# LOT 3, PADMARK BUSINESS PARK FIL. NO. 1

EL PASO COUNTY, STATE OF COLORADO  
GRADING & EROSION CONTROL PLAN

GRADING & EROSION CONTROL PLAN  
LOT 3, PADMARK BUSINESS PARK FIL. NO. 1  
JOB NO. 44-031  
DATE PREPARED: JUNE 29, 2018  
DATE REVISED:

EL PASO COUNTY FILE NO. PPR 18-000

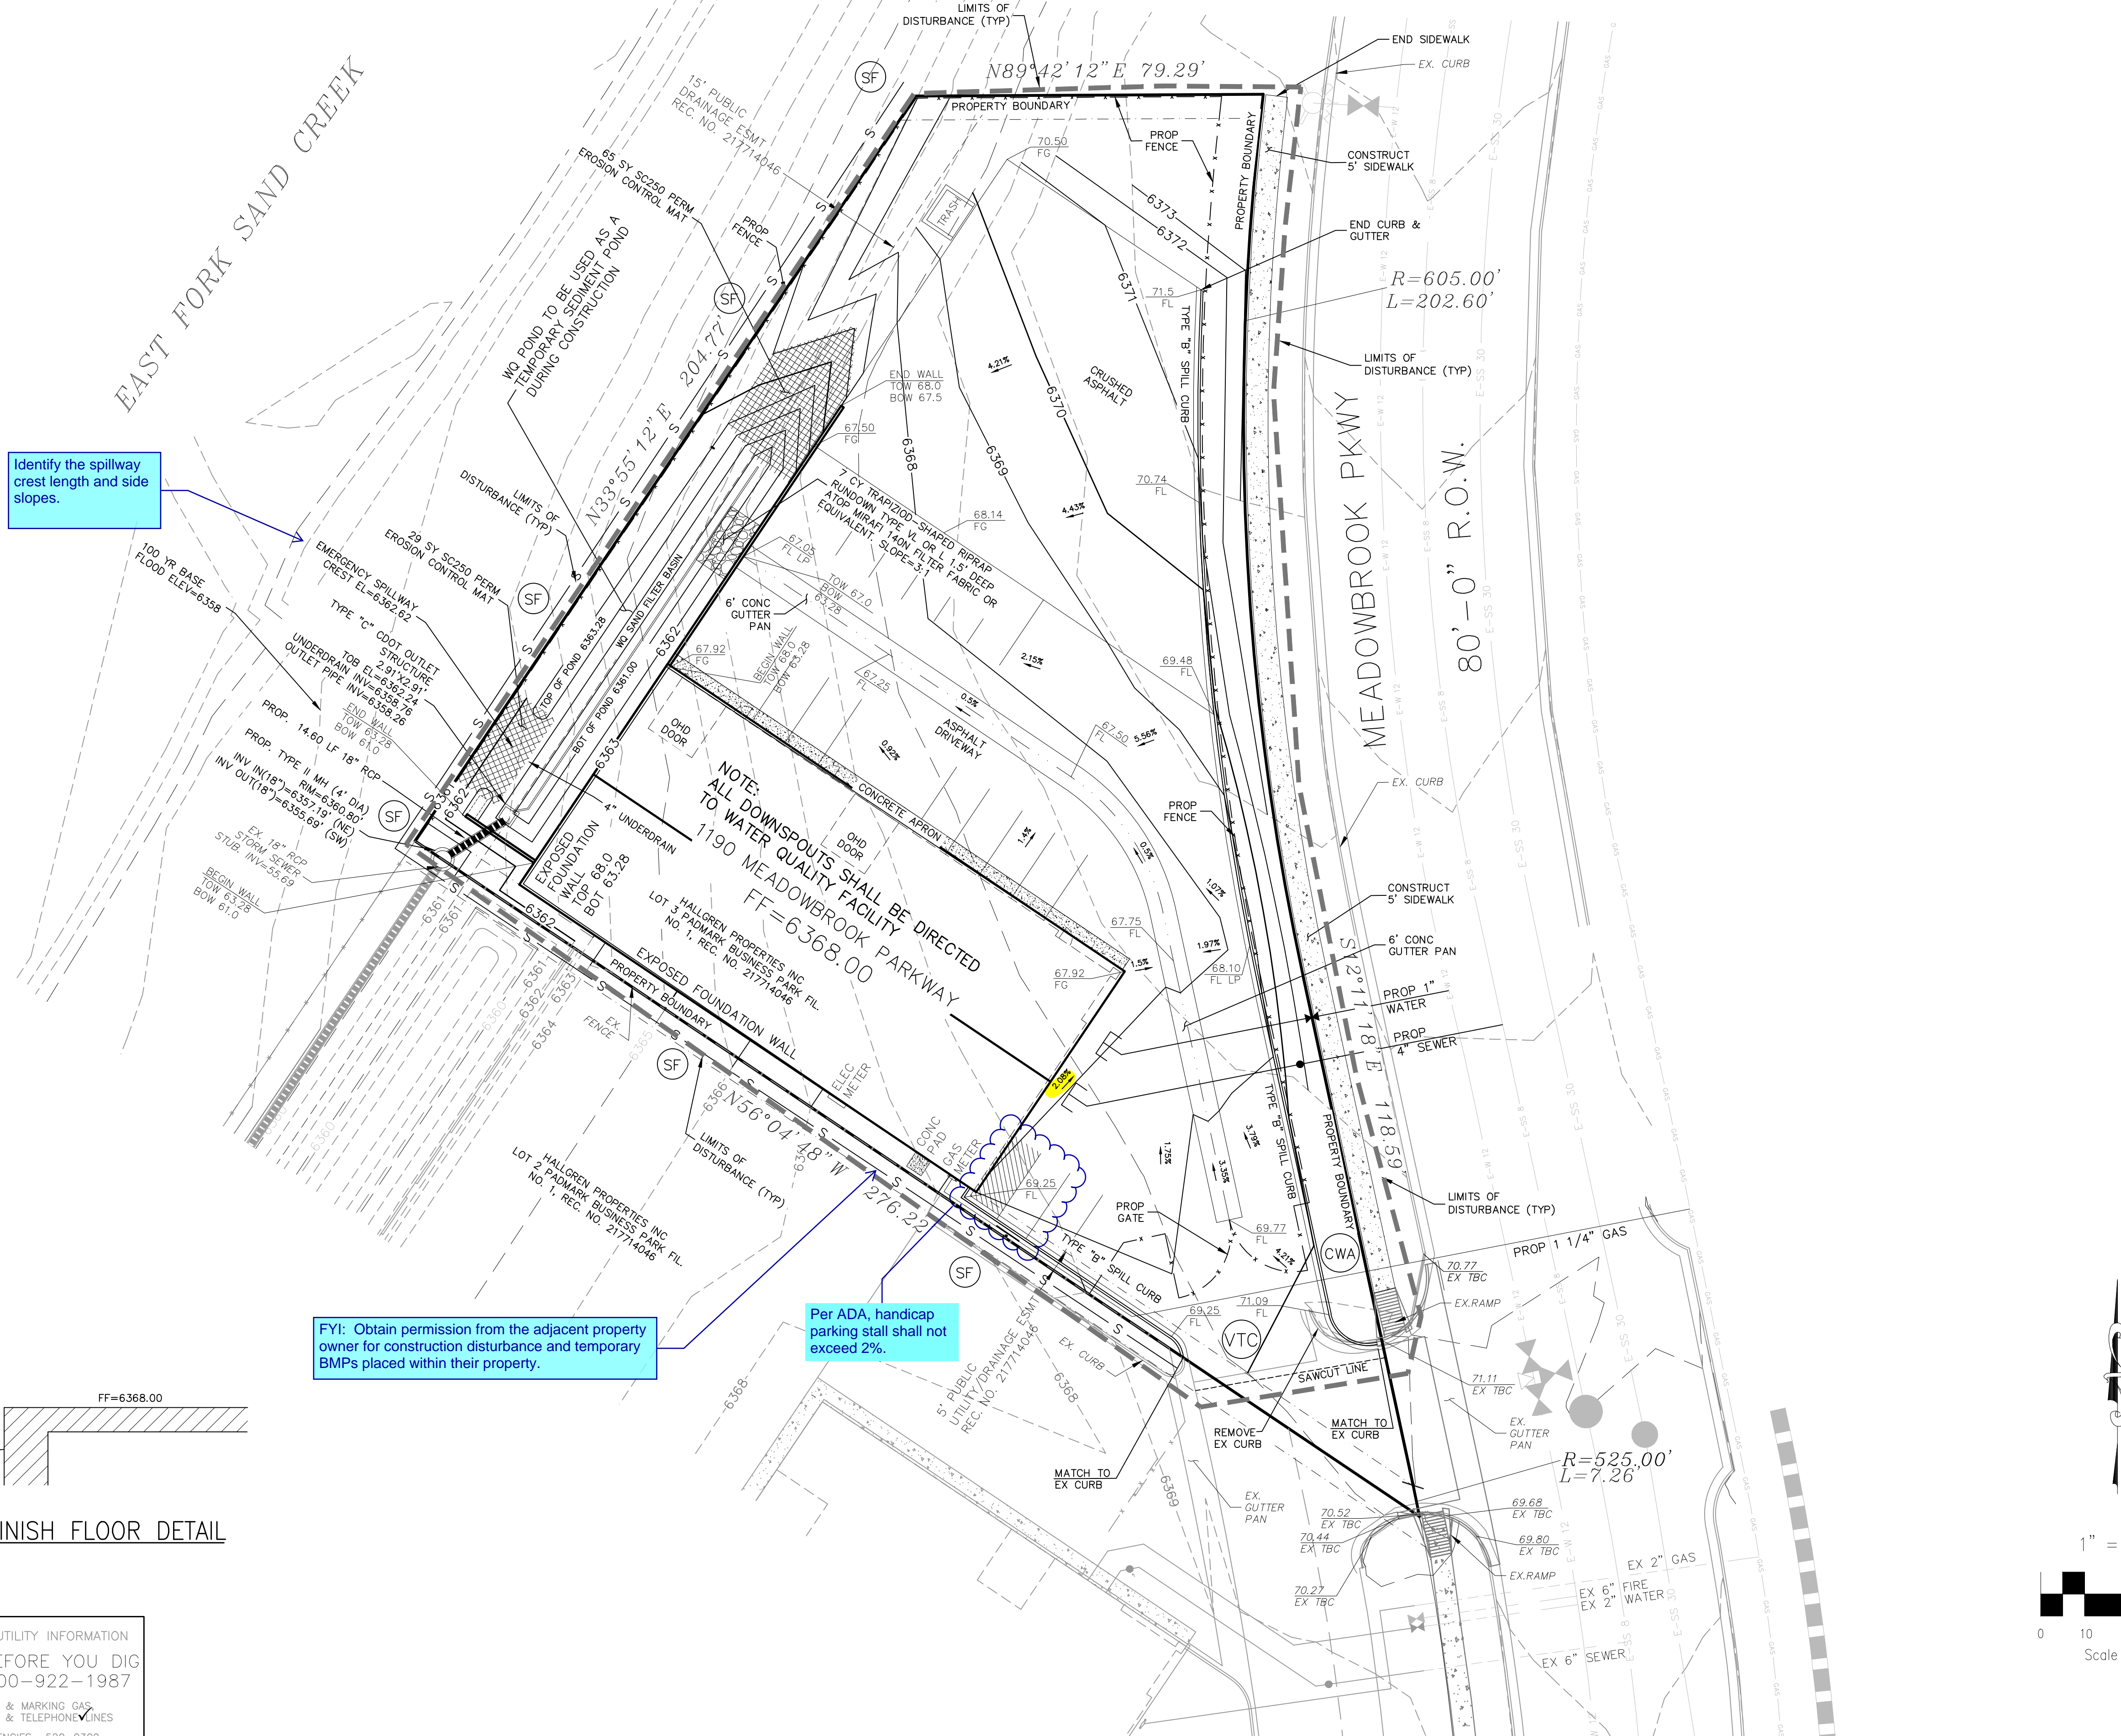
Identify the spillway crest length and side slopes.

FYI: Obtain permission from the adjacent property owner for construction disturbance and temporary BMPs placed within their property.

Per ADA, handicap parking stall shall not exceed 2%.
